KELLER SPRINGS LOFTS

RFI

RFI #: 163
 Date: 6/26/2012
 Job: EB-02 Keller Springs Lofts
 Phone: 877-777-5115

Drawing: S2.11S Spec Section:
 Cost Impact: None Schedule Impact: None

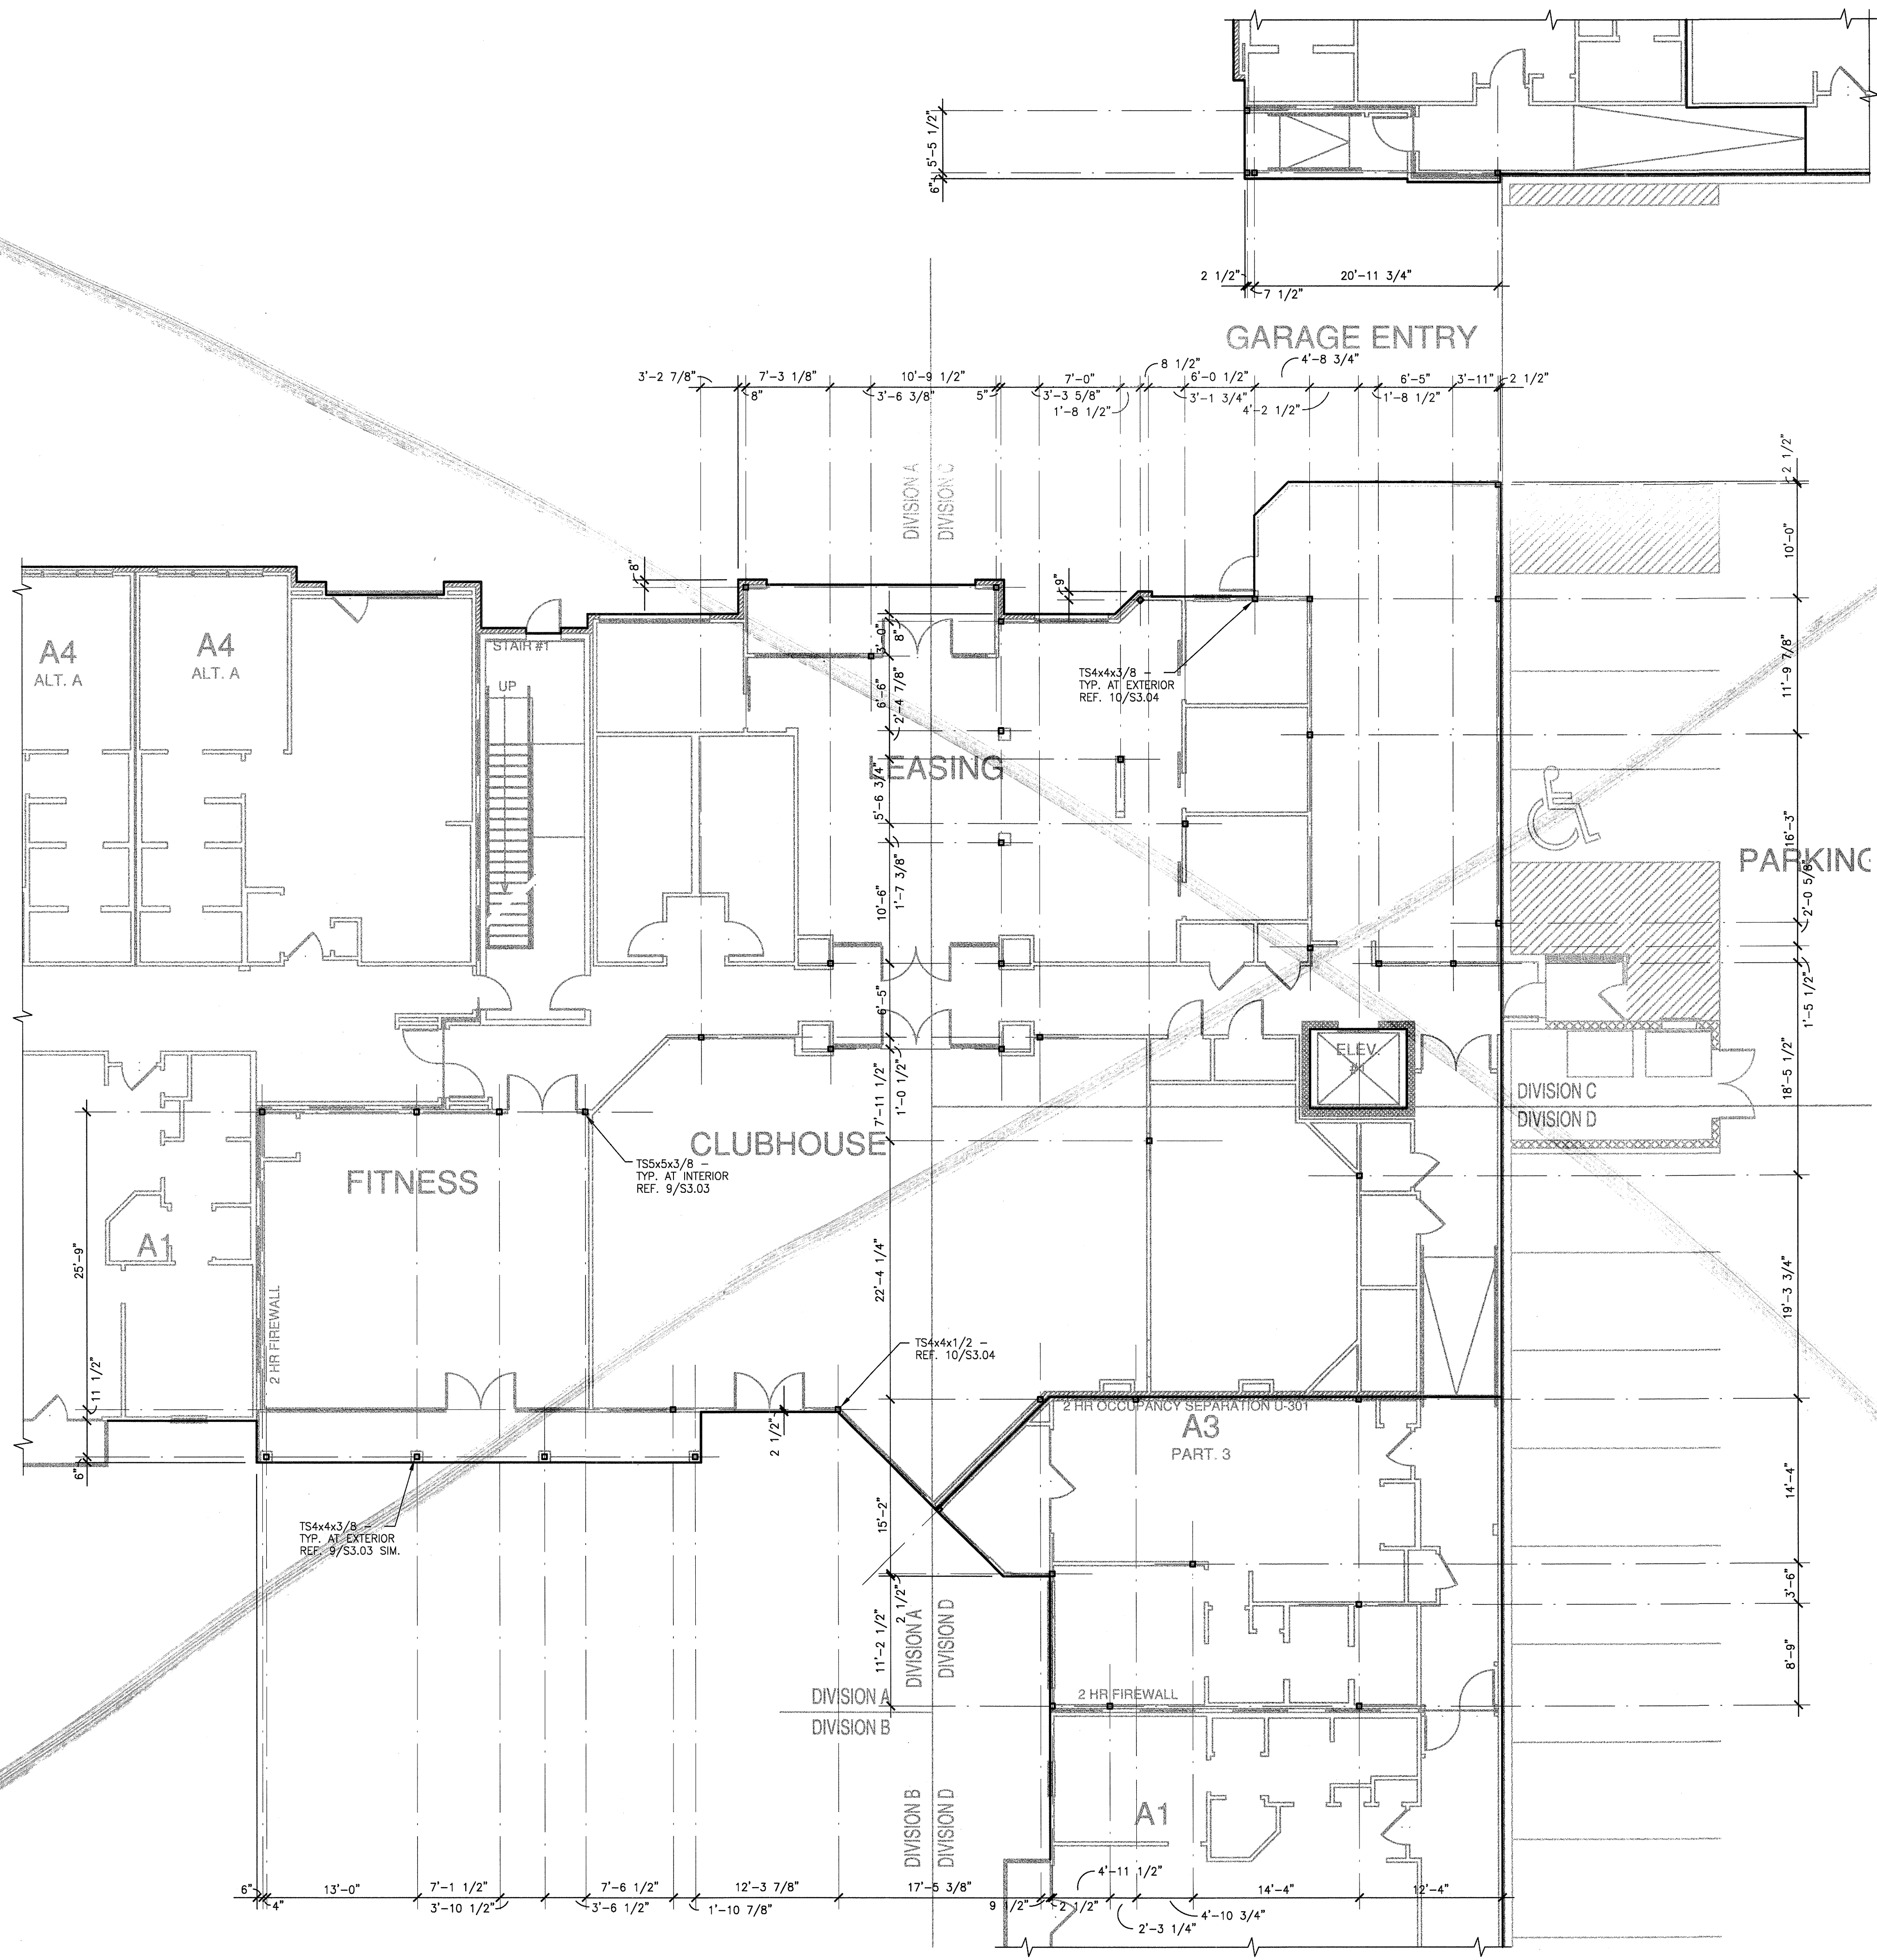
Request: Date Required: 4/2/2012
 Please provide dimensions needed at clouded areas on the attached drawing.

Drawing: S2.12
Cost Impact: None Spec Section:
Schedule Impact: None

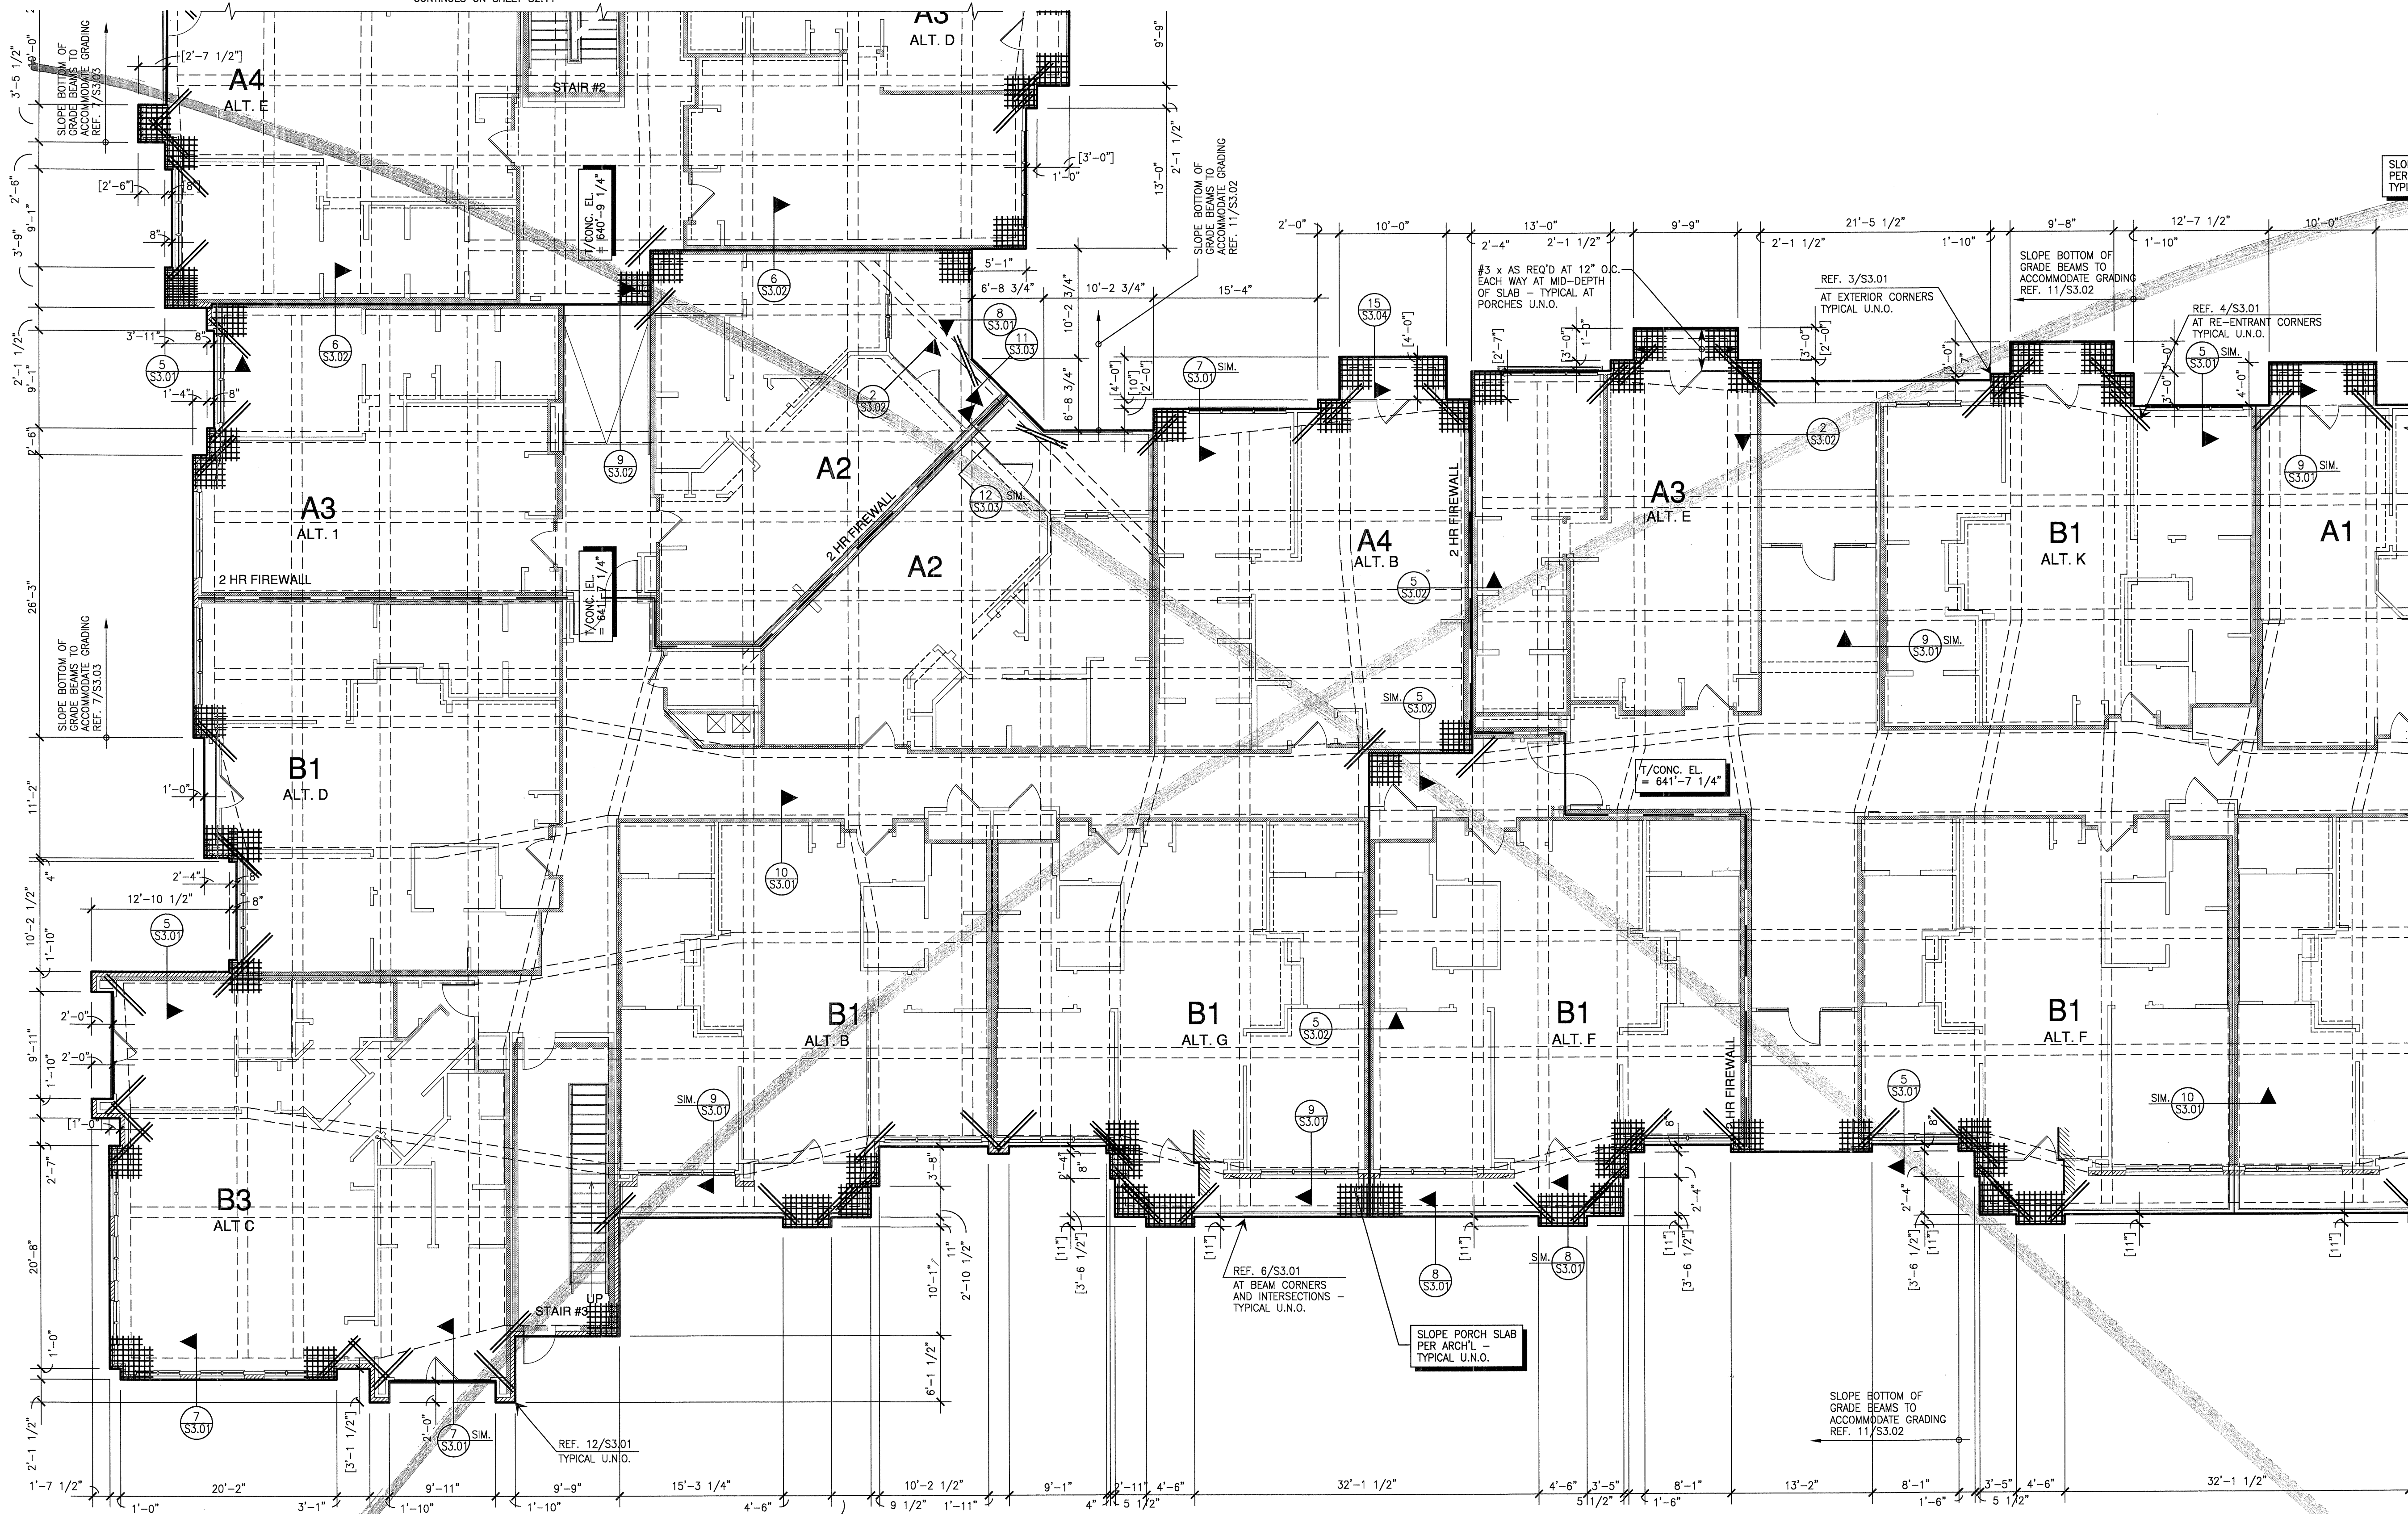
Request: Please confirm that we are OK to drive vehicles (trucks, bobcats, forklifts) on the slab in the area highlighted on the attached drawing. This is in Pour #11. **Date Required: 7/11/2012**

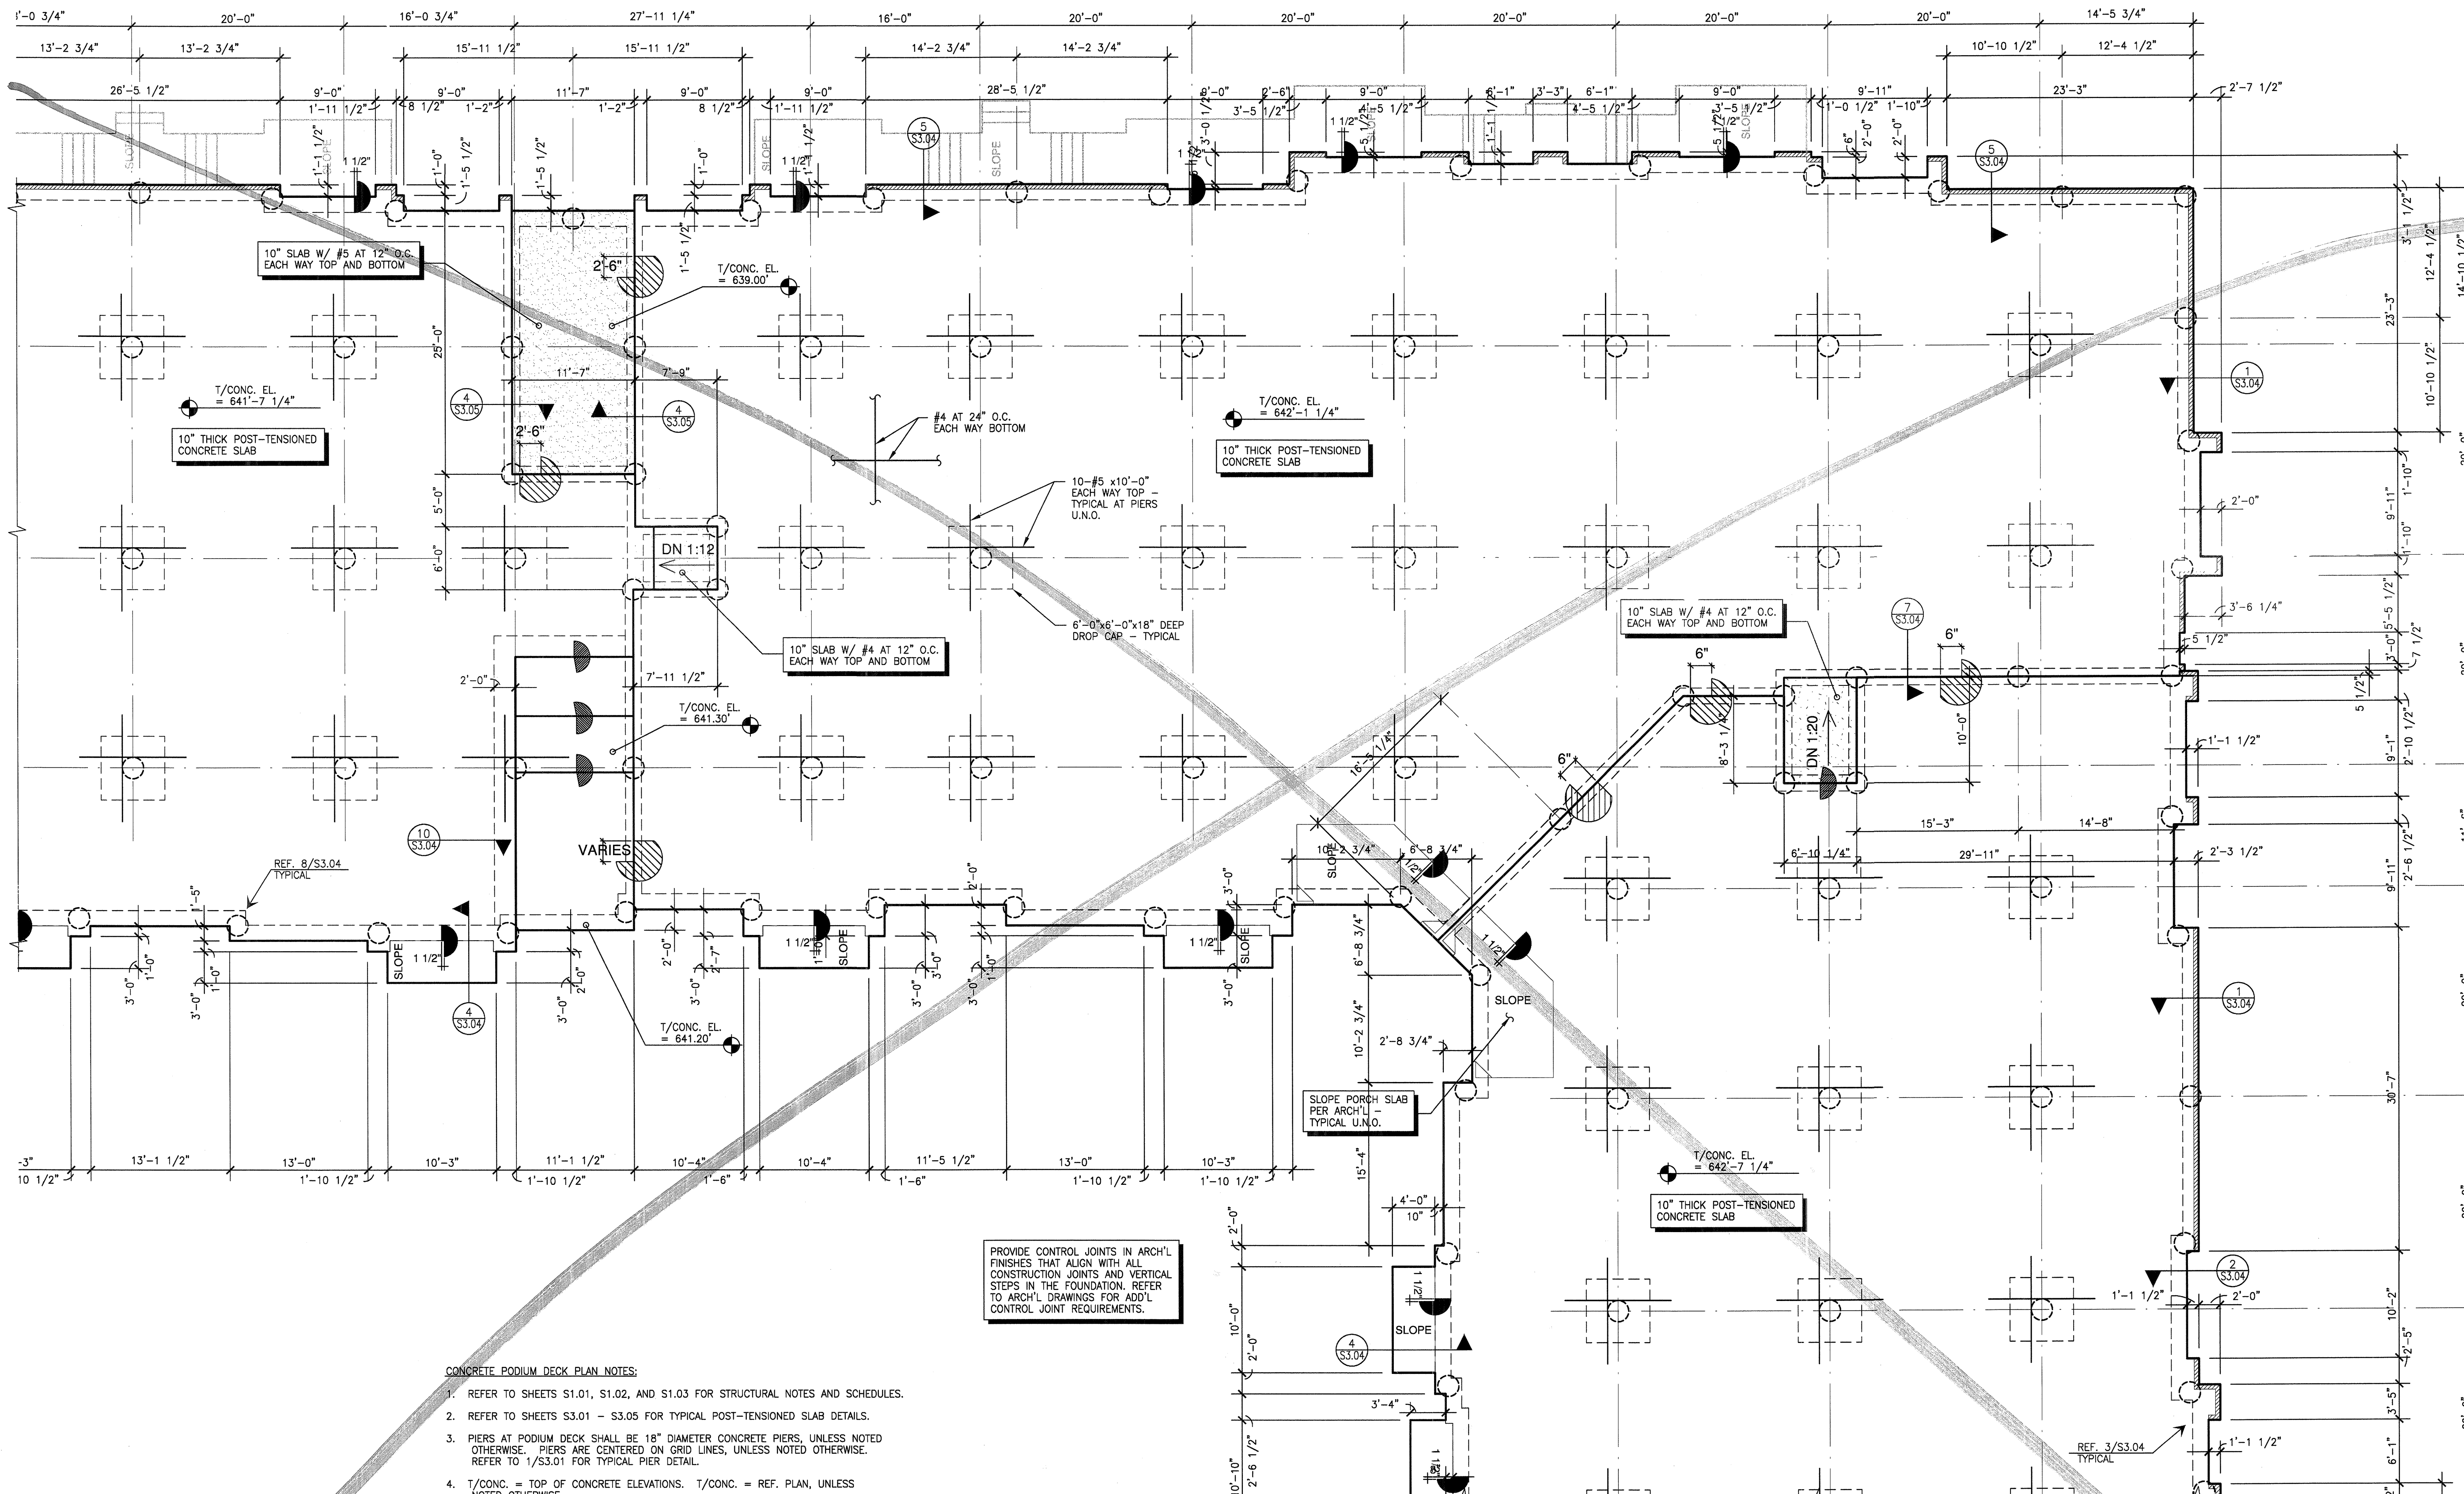
Request: At the Southeast corner of Pour #12 there is a corridor into the building that is sloped to the outside. The plans do not call for the piers or the beam to be lower at that area. This will cause the slab to be less than 10". Brande Parkey was on-site 6/4/12 for this grade beam inspection and directed us to leave out this section until a solution was decided. Please advise. **Date Required:** 6/21/2012
